APPLICATION NO.	FILING DATE	FIRST NAMED INVENTOR	ATTORNEY DOCKET NO.	CONFIRMATION NO.
10/644,517	08/19/2003	Nobuaki Honda	03490/LH	5967

Office Action Summary

NON-FINAL OFFICE ACTION

FIG. 1

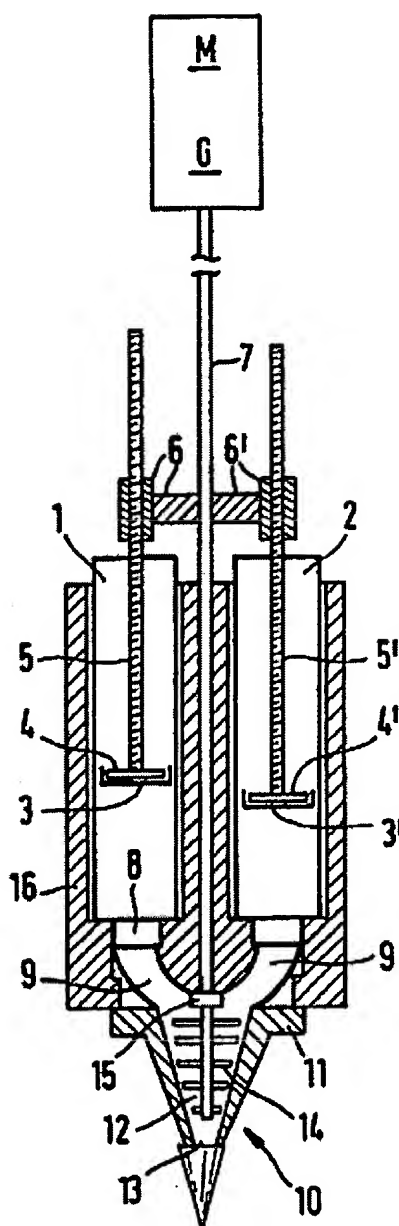
12. Claims 4 and 10 are rejected under 35 U.S.C. 102(b) as being anticipated by EP 313519 A1.

EP 313519 A1 discloses an apparatus in Fig. 1 as seen below comprising plural inlets 9; outlet 13; multistage channel 11 with channel stages 14 including channels 12 therein; the multistage channel 11 having a decreasing passage sectional area toward the outlet 13 as seen in Fig. 1; a division section (the upstream portion of a member 14); a confluence section (the downstream portion of member 14); and a diversion section (the tapering inner wall of channel 11).

Fig. 3

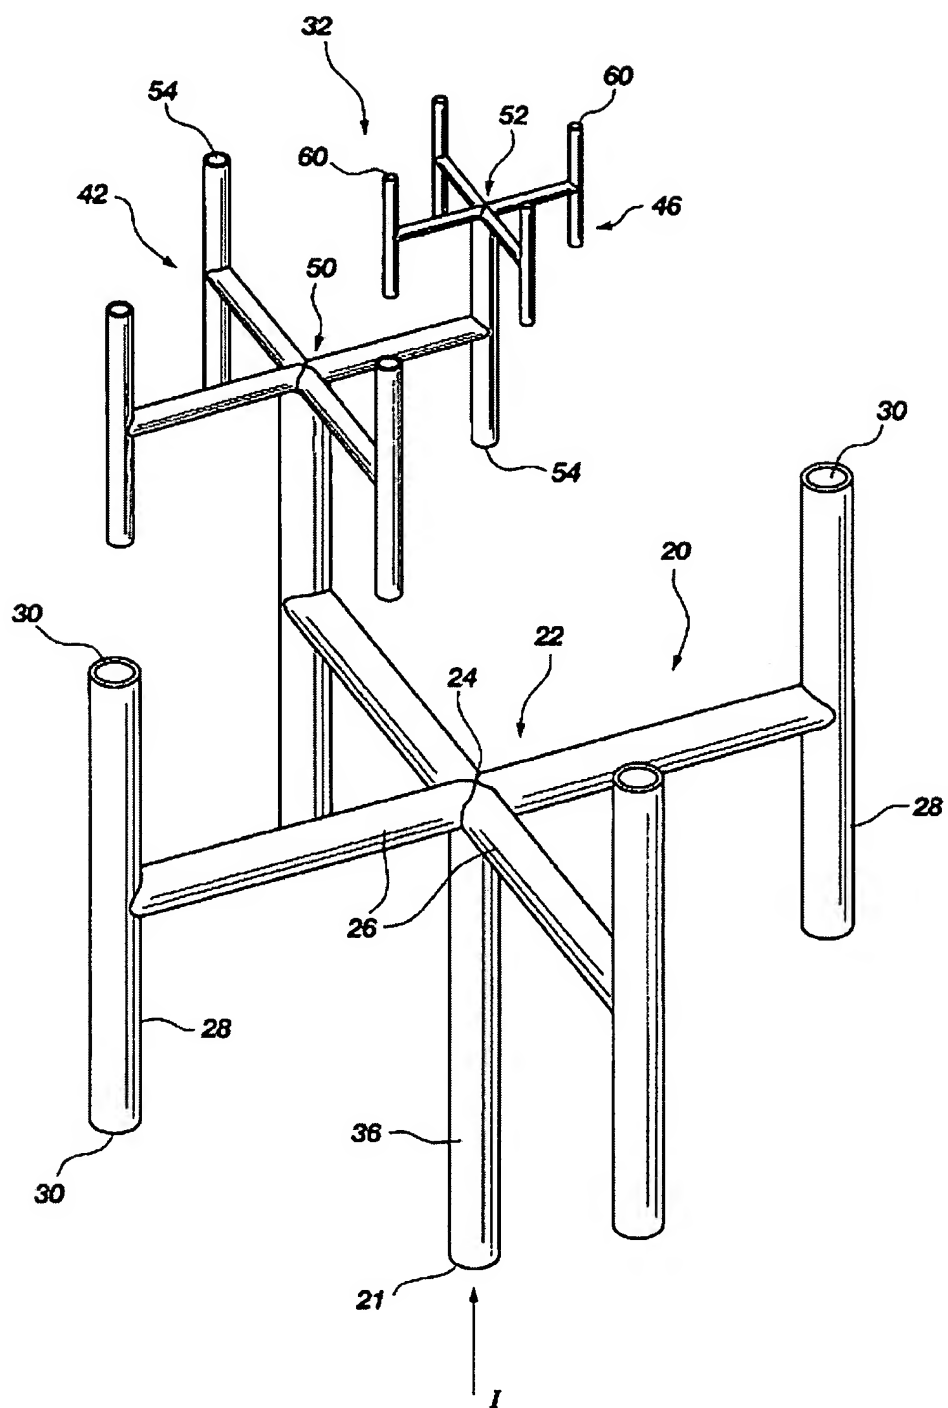
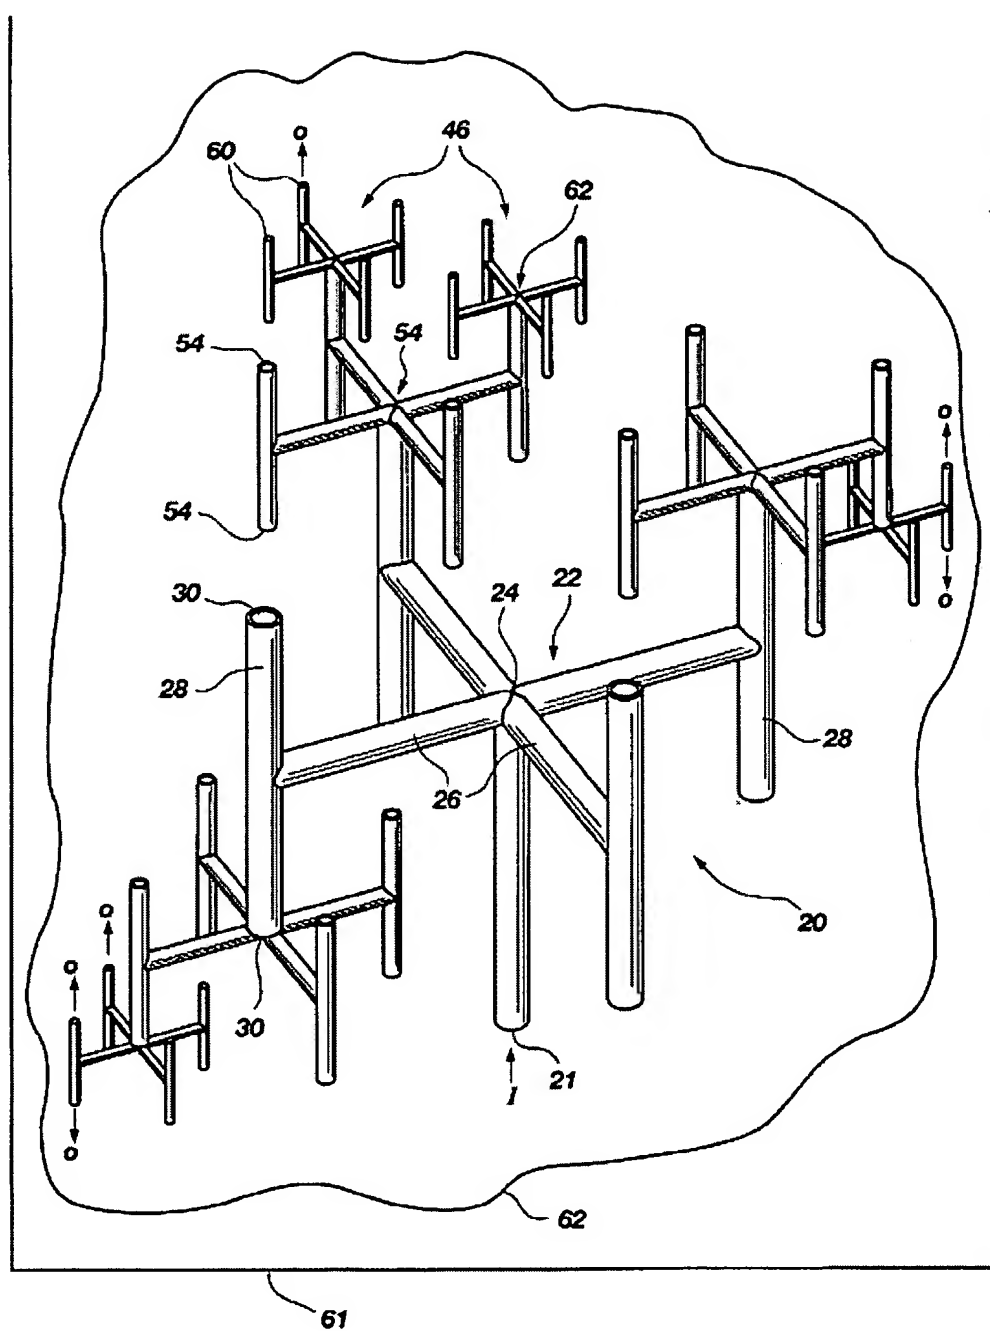
13. Claim 4 is rejected under 35 U.S.C. 102(b) as being anticipated by Kearney (US 5,938,333).

The patent to Kearney '333 discloses an apparatus as seen below comprising plural inlets 26 (Fig. 3); outlet (one of elements 60 - see "O" in Fig. 3); a multistage channel (Fig. 3) with channel stages 54, 46 including channels therein; the multistage channel having a decreasing passage sectional area as the cross section of the channels decreases toward outlet 60 as seen in Fig. 3.

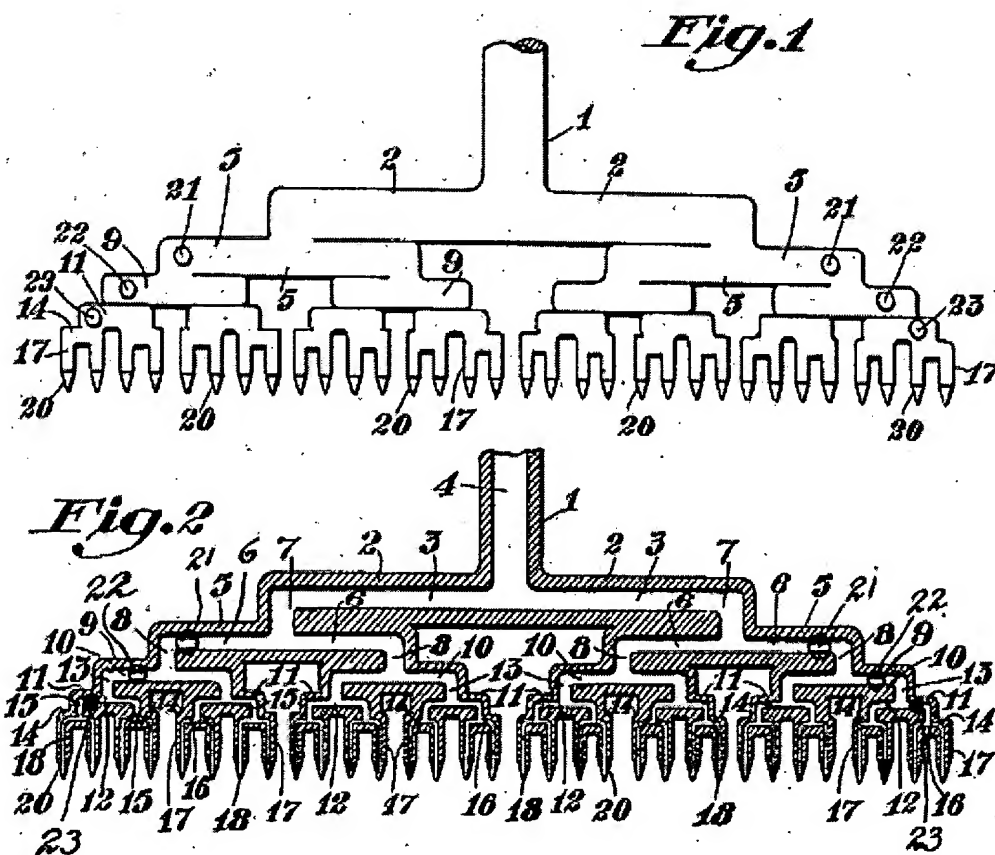
14. Claim 4 is rejected under 35 U.S.C. 102(b) as being anticipated by Sykora (US 1,409,259).

The patent to Sykora discloses an apparatus as seen below comprising plural inlets 6; outlet (one of elements 18); a multistage channel (Fig. 2) with channel stages 8, 10, 12, 13, 14 including channels therein; the multistage channel having a decreasing passage sectional area as the cross section of the channels decreases toward outlet 18 as seen in Fig. 2.

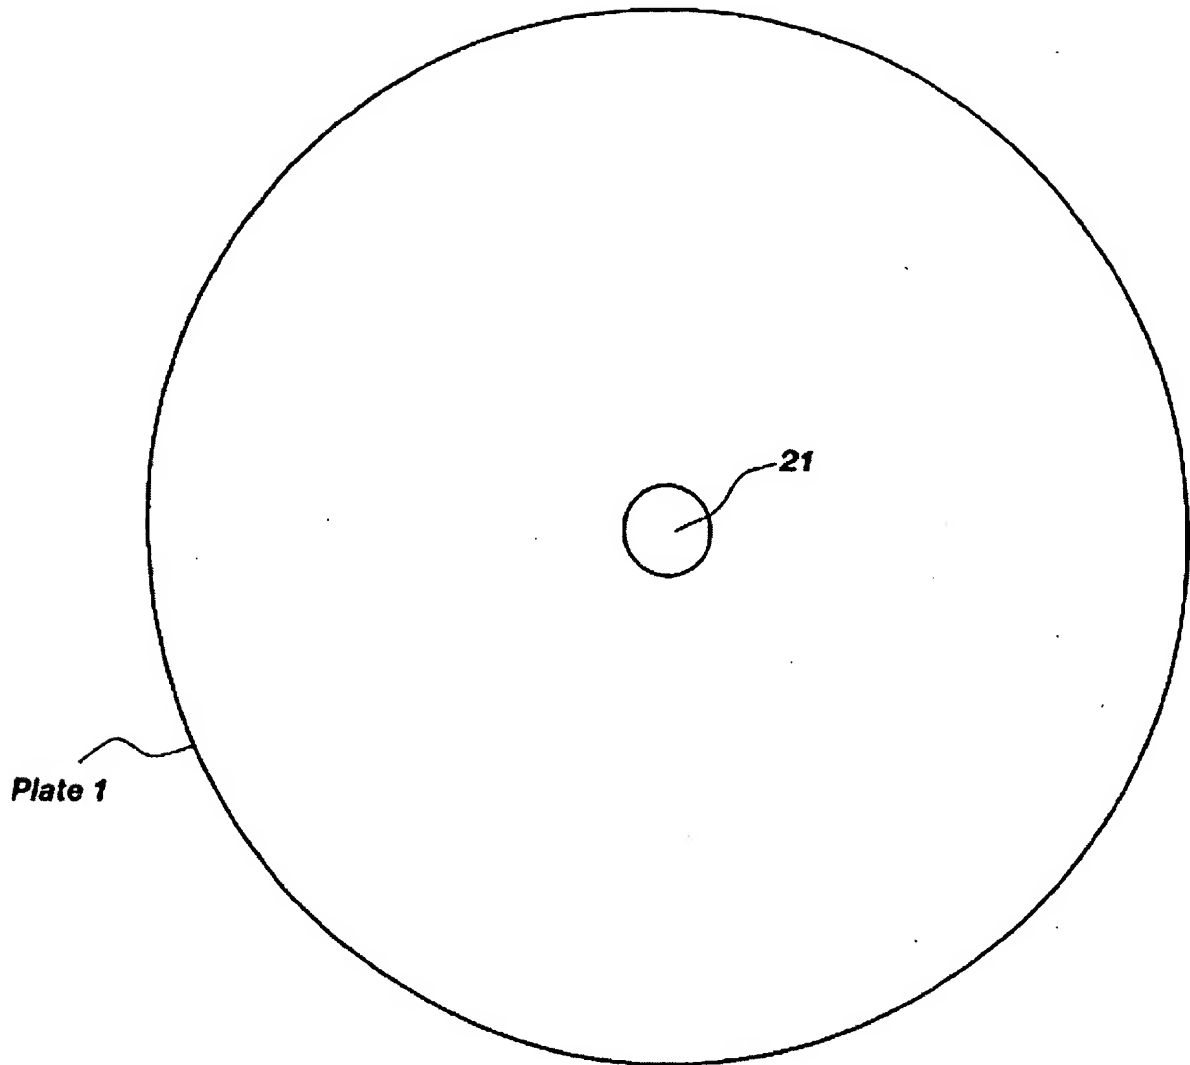
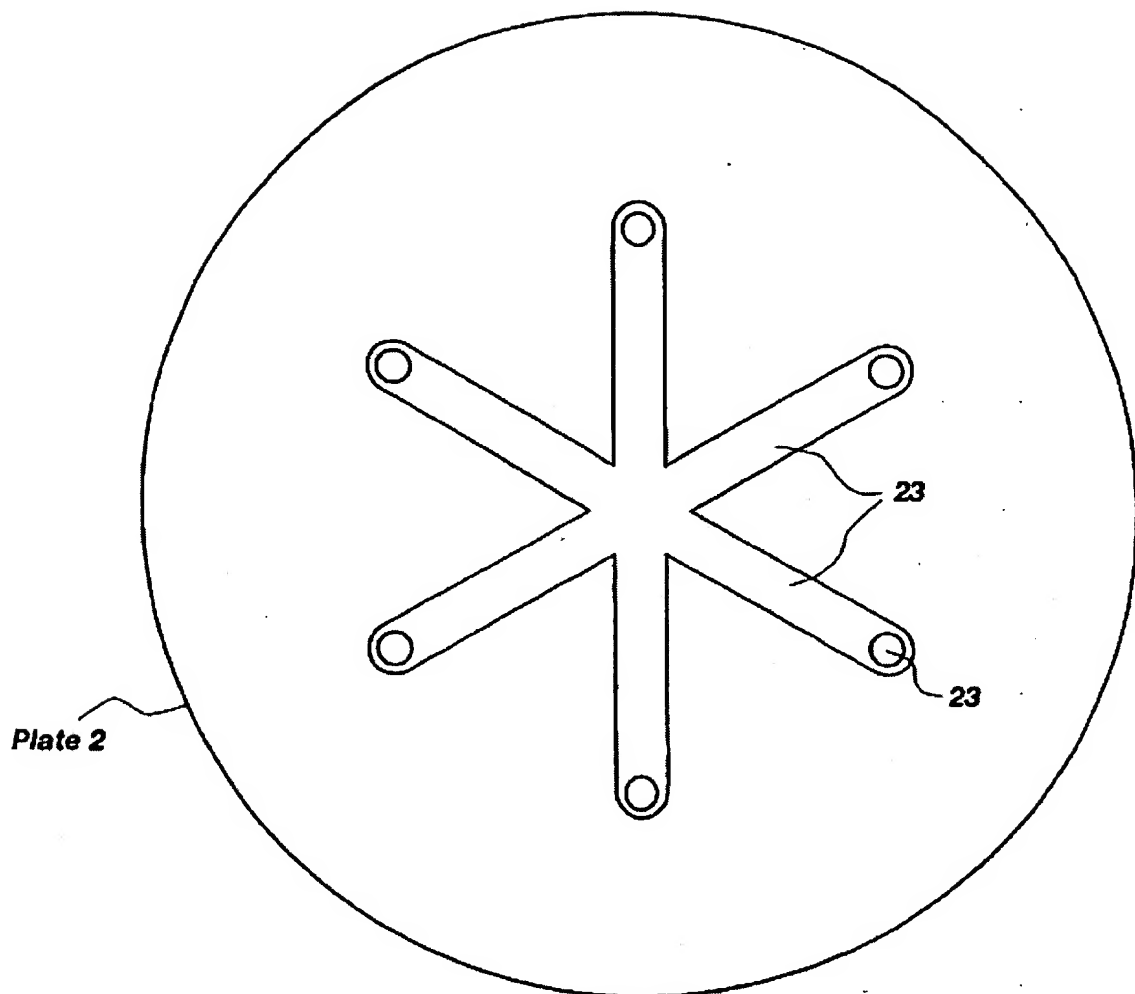
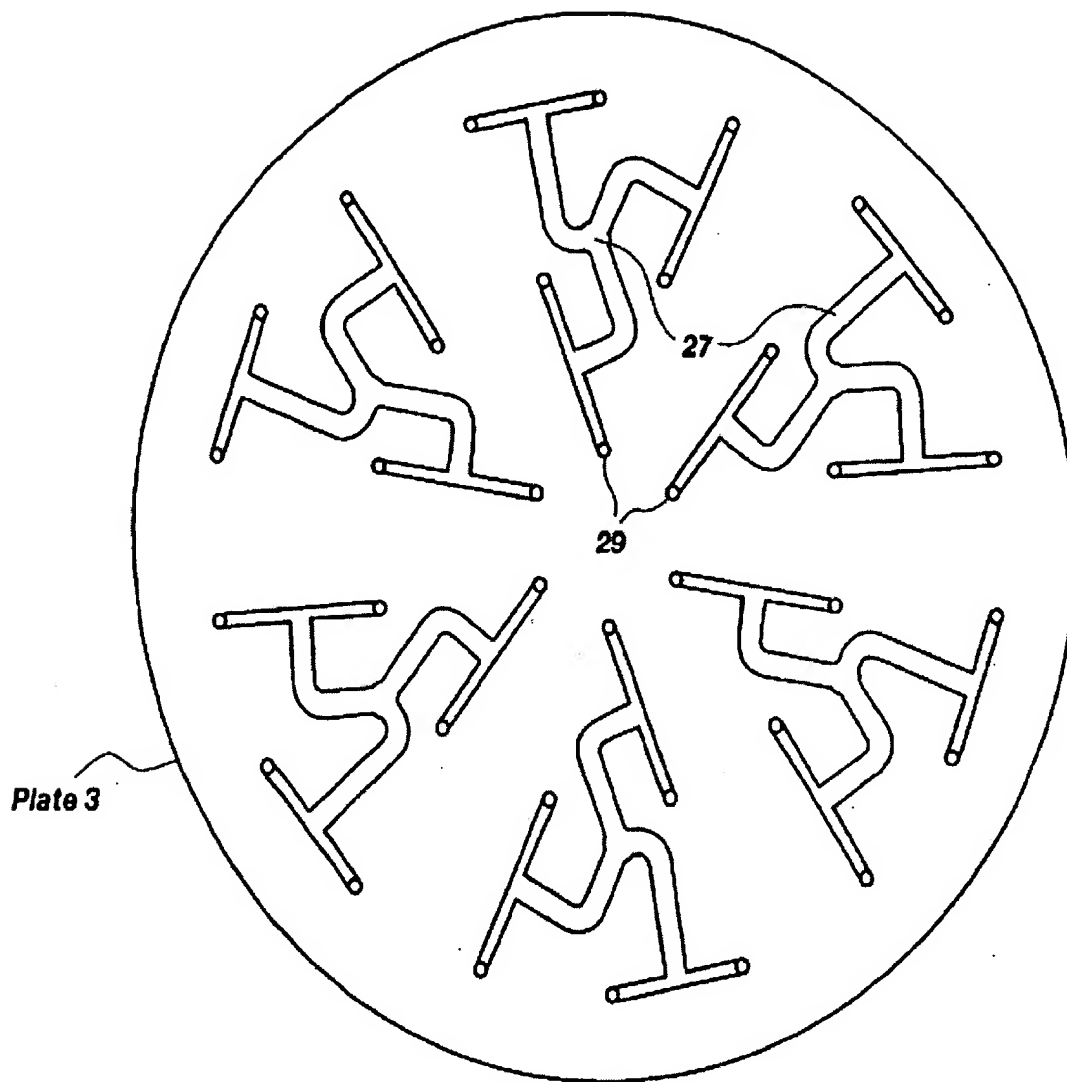
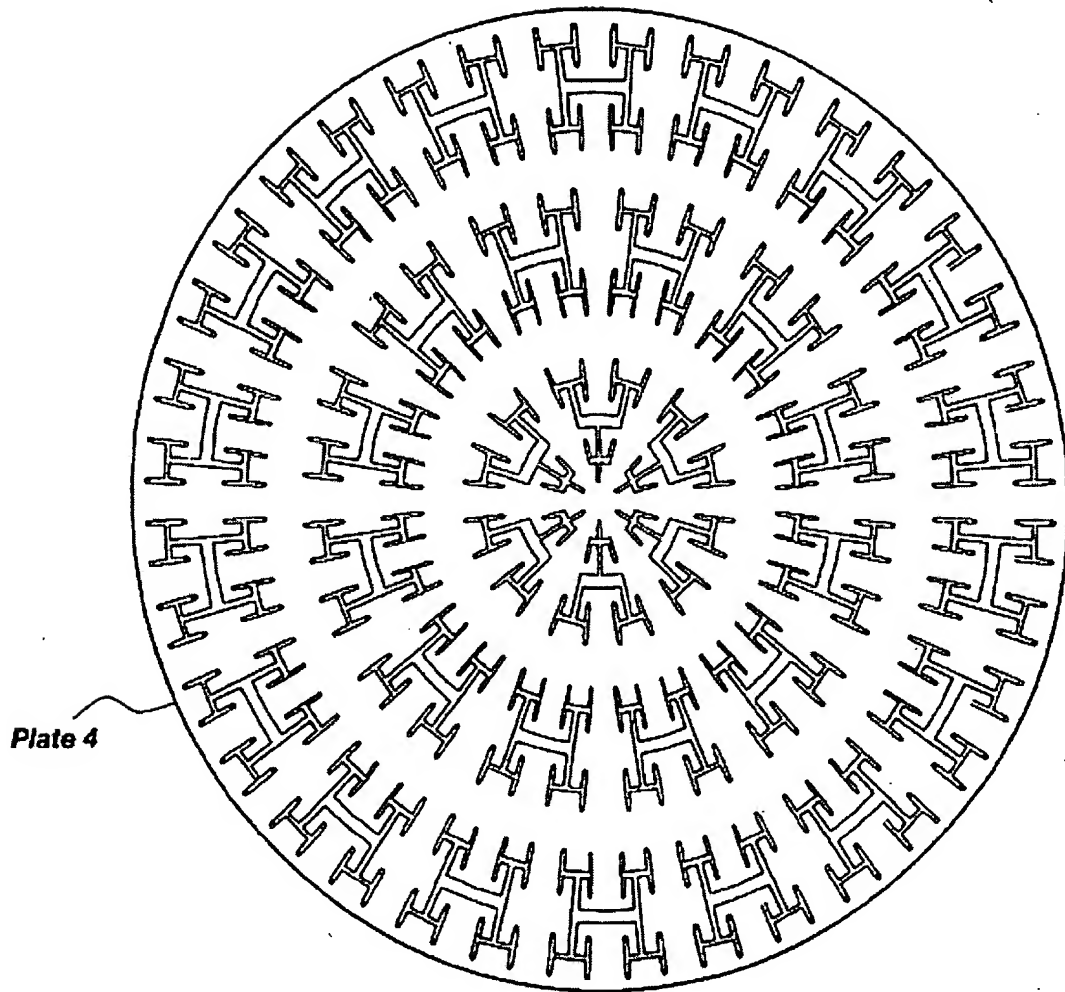
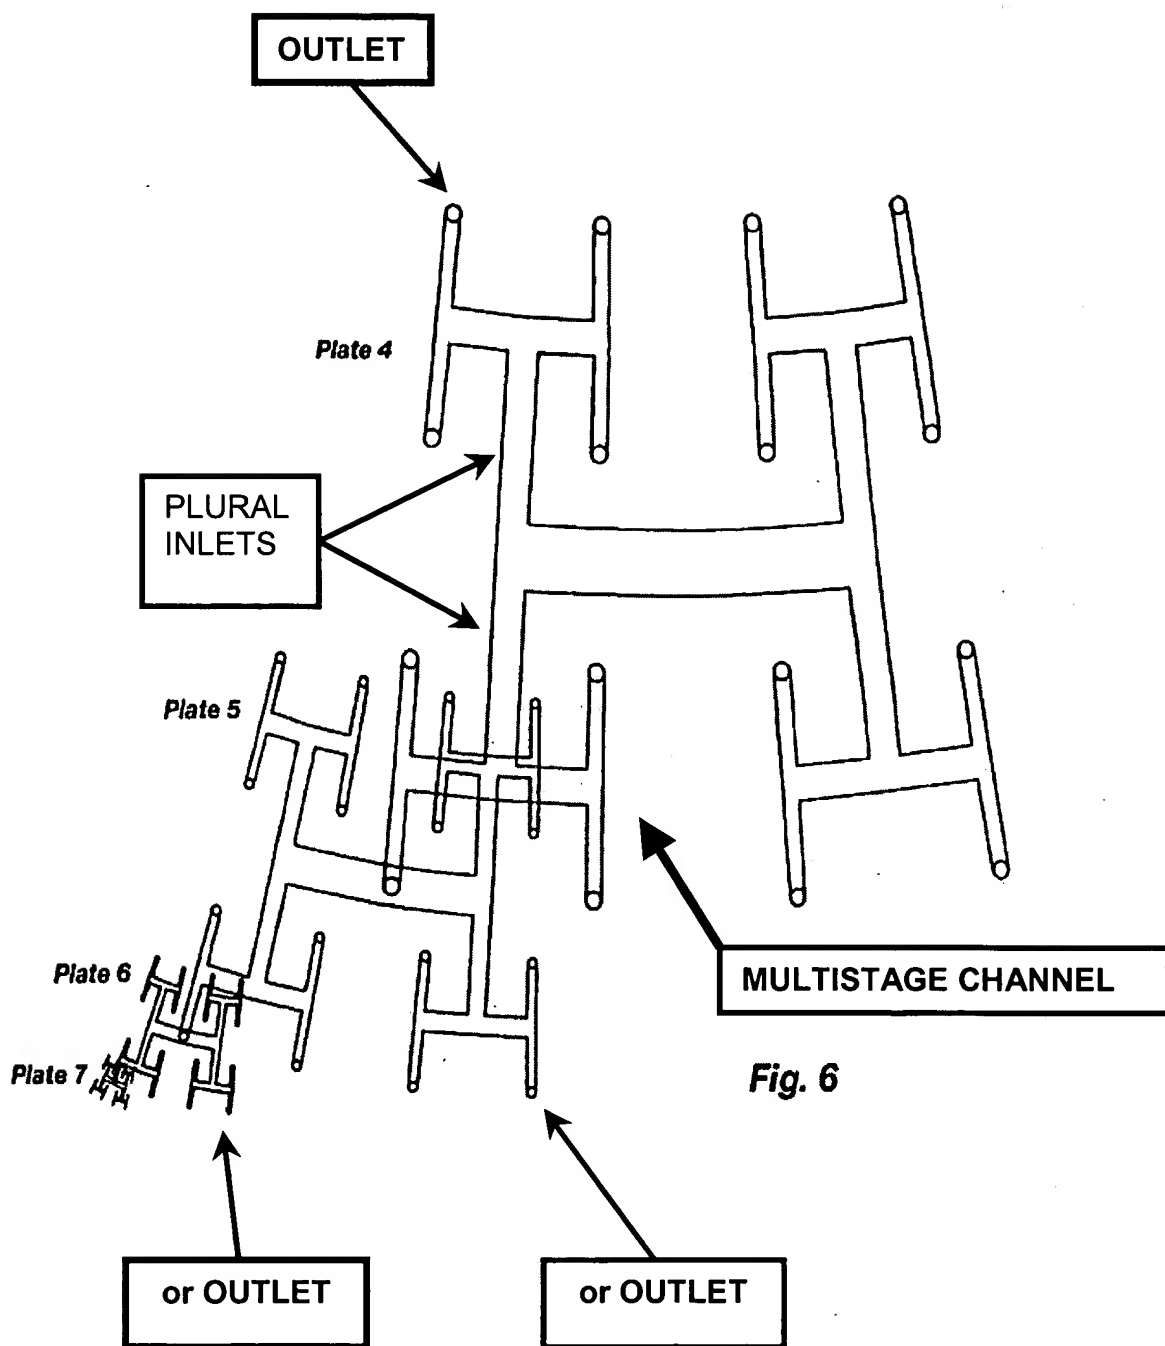
15. Claim 4 and 13-15 are rejected under 35 U.S.C. 102(e) as being anticipated by Kearney et al. (US 6,616,327).

The patent to Kearney et al. '327 discloses an apparatus as seen below comprising plural inlets as denoted below; an outlet as denoted below; a multistage channel (Fig. 6) with channel stages including channels therein; the multistage channel having a decreasing passage sectional area as the cross section of the channels decreases toward the outlet as seen in Fig. 6; and the recited plates 1-8 with mixing units as seen in Figs. 1-6.
